Product Change Notification

INDUCTIVE COMPONENTS

Bourns® Model SRF1260 & SRF1280 Series Change to the Amount of Epoxy

*Figure 2: New -
Epoxy in Four Spots*

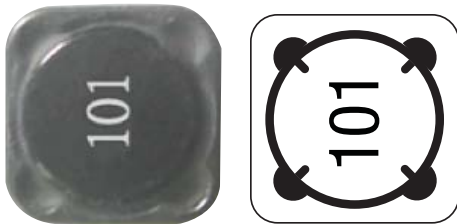
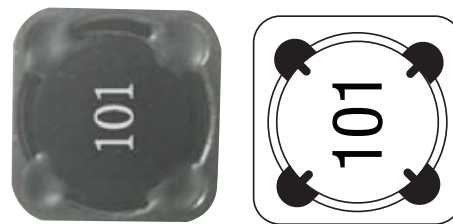
The production process for the Bourns® Model SRF1260 and SRF1280 Series Dual-Winding Shielded Power Inductors will be modified to reduce the amount of epoxy applied between the inductor core and shield. Currently, the inductor core and shield are held together with epoxy that is manually applied completely around the core (see figure 1). The production process will now be automated to apply the epoxy in four spots to bond the core and shield (see figure 2).

This Product Change Notification reflects an anticipated positive change to reliability. The reduction in the amount of epoxy in between the core and shield, which will create free space for material thermal expansion, should help reduce the risk of core cracking during the reflow soldering process.
